Technology Inclusive Content of Application Project Public Meeting

August 17, 2021
Microsoft Teams Meeting
Bridgeline: 301-576-2978
Conference ID: 934 684 217#

TICAP Public Meeting

- The purpose of this meeting is to discuss with the nuclear industry issues related to the draft guidance document for safety analysis report (SAR) content for an advanced reactor application based on the licensing modernization project (LMP) described in NEI 18-04
- Key documents associated with this meeting are referenced in the meeting notice and include:
 - Industry-developed draft TICAP guidance document ([ADAMS Accession No. ML21215A577](#))
 - Industry White Paper on Principal Design Criteria ([ADAMS Accession No. ML21214A008](#))
- Continuation of public meetings held on May 11, May 19, May 26 and June 23, 2021
- Additional background available on the NRC ARCAP/TICAP public webpage (see: <https://www.nrc.gov/reactors/new-reactors/advanced/details.html#advRxContentAppProj>)

Figure adapted from previous Southern presentation

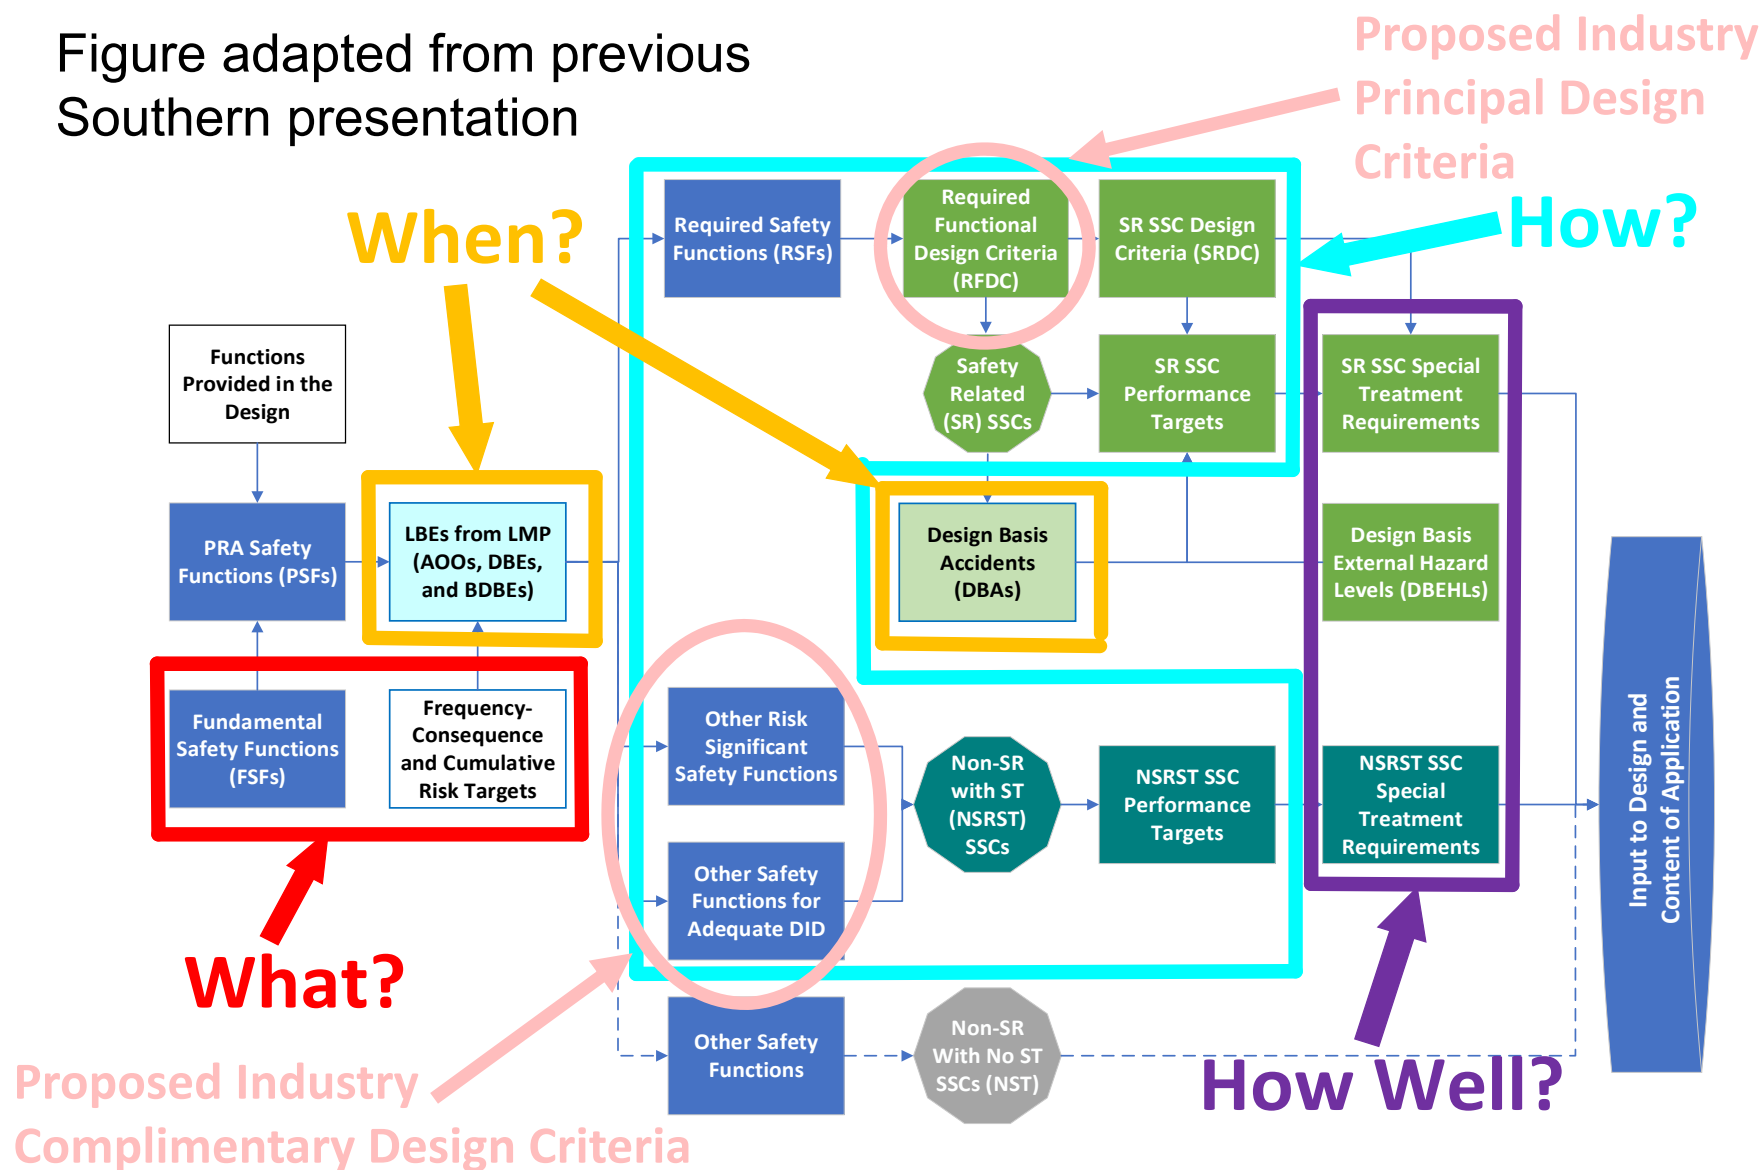
- The NRC staff is still reviewing the Industry White Paper and the question on whether an exemption request is needed regarding the purpose of PDCs
- At issue is the industry proposal to equate the Required Function Design Criteria (RFDCs) in NEI 18-04 to PDCs. As stated in the Industry White Paper, the RFDCs address the "How" portion of the design, whereas historical PDC address both "How" and "How Well."

- The NRC staff is considering the following options to move forward on TICAP guidance while the PDC issue is under review:
 - The NRC staff's draft TICAP Regulatory Guide white paper may be updated after considering the following options:
 - The LMP-based approach provides an acceptable approach for identifying PDCs associated with off-normal conditions
 - Review the applicant's proposed treatment of areas associated with normal operations and areas associated with proposed special treatments (e.g., quality assurance, protection from external hazards, testability, inspectability) and identify if PDCs, as well as proposed complimentary design criteria (CDCs), are appropriate in this area.
 - The LMP-based approach cannot be reconciled with the current PDC framework under 10 CFR Parts 50 and 52, and an exemption may be required.
